APPENDIX 15-5

ROAD SAFETY AUDIT

Knockshanvo Wind Farm

Stage 1 Road Safety Audit

Figure 1.1 – Transition Zone (Left) & Locations 28, 29, 30 & 31 (Right)

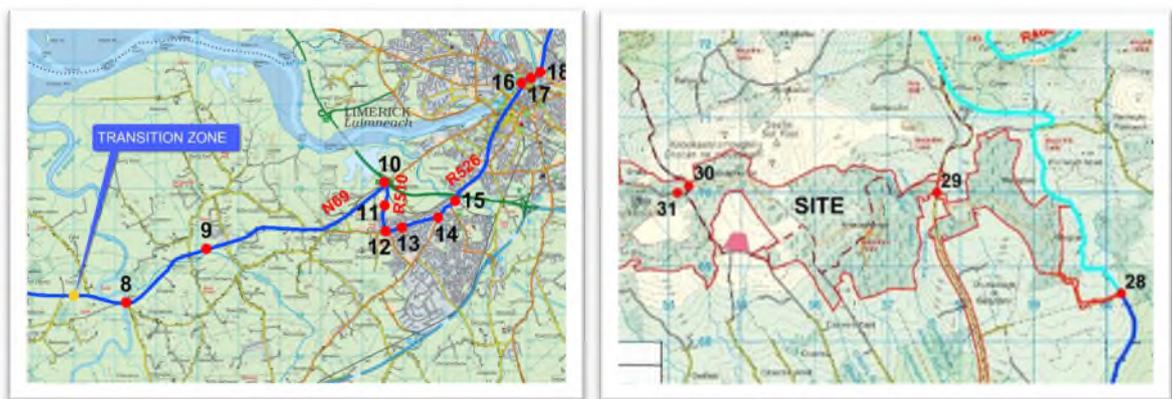
2.1 Problem: Sightlines Partially Obscured by Field Boundary

Location: Transition Zone | Field Boundary Flanking Accesses

Sightlines to the left appear to be partially obscured by the existing field boundary, which includes ditch foliage and some trees. This could lead to side impact type collisions within the access junction's conflict zone.

The ditch should be modified to ensure that an appropriate sightline is provided at the location described.

2.2 Problem: Sightlines Partially Obscured by Field Boundary

Location: Location 28 – Access Junction A | Field Boundary Flanking Accesses

The access sightlines appear to be obscured by the existing field boundary, which includes ditch foliage and some trees. This could lead to side impact type collisions within the access junction's conflict zone.

The ditch should be modified to ensure that an appropriate sightline is provided at the location described.

2.4 Problem: Constrained Geometry of Access Roads

Location: Locations 30 & 31 – Access Junctions C & D | Narrow Forestry Roads

The forestry access roads were constrained in terms of cross section, horizontal alignment and also vertical alignment. This could lead to loss of control type collisions and opposition type conflicts (where opposing vehicles have difficulty passing each other) for wind farm construction traffic, including abnormal loads.

The geometry of the roads should be improved to accommodate the anticipated wind farm construction traffic. The road improvements should be supported by suitable temporary traffic management interventions to further mitigate the risks described.

Problem Reference (Section 2)	Designer Response Section			Audit Team Response Section
	Problem Accepted (yes / no)	Recommended Measure Accepted (yes / no)	Alternative Measures or Comments	Alternative Measures Accepted (yes / no)
2.1	Yes	Yes	See Note 1	Comment noted & accepted.
2.2	Yes	Yes	All vegetation and foliage will be cleared in order to provide the 3m x 160m visibility splays along the R465, as shown in Figure 15-7 of the EIAR.	Comment noted & accepted.
2.4	Yes	Yes	See Note 2	Comment noted & accepted.

It is acknowledged that visibility splays are constrained at the location of the proposed Temporary Transition Compound. Appropriate traffic management measures are set out in Section 15.1.2.3 of the EIAR. During the construction of the proposed TTC access to and from the site off the N69 will be controlled by traffic management measures, including temporary signage in accordance with the “Traffic Signs Manual, Section 8 – Temporary Traffic Measures and Signs for Road Works” (DoT now DoTT&S) and “Guidance for the Control and Management of Traffic at Roadworks” (DoTT&S). Construction staff (flagman) will be present at this location during all times that deliveries are made to and from the site. The site will be closed to all traffic by means of fencing at all other times.

All construction, operational and decommissioning traffic requiring access to turbines Nos 1 to 3 will require to cross the L-30144-0 local road at Access Junction C, with the proposed junction layout shown in Figure 15-11 of the EIAR. At present there is an existing agricultural/forest access that links into the L-30144-0 local road from the east. It is proposed to retain this access, with 6m junction radii proposed in accordance with the existing access.

A new access is proposed on the west side of the L-30144-0 local road. This access is for the purpose of development generated traffic only, with no turning movements permitted. Nominal junction radii of 3m proposed at this location. It is proposed that the access on the western side is gated and opened during construction periods and for maintenance visits only.

The junction layout proposed at Access Junction D, also shown in Figure 15-11, takes the form of 2 staggered priority junctions with the L-30426-23 local road that will be in place permanently during the operational phase, with temporary routes through the junction to be used during the construction phase only.

The gravel track nature of the L-30426-23, together with alignment of the existing road, results in speeds being very low (ie approx. 30 km/h). For the assessment of visibility splays a design speed of 50 km/h is adopted at this location, with 2.4m x 70m visibility splays shown in Figure 15-12.
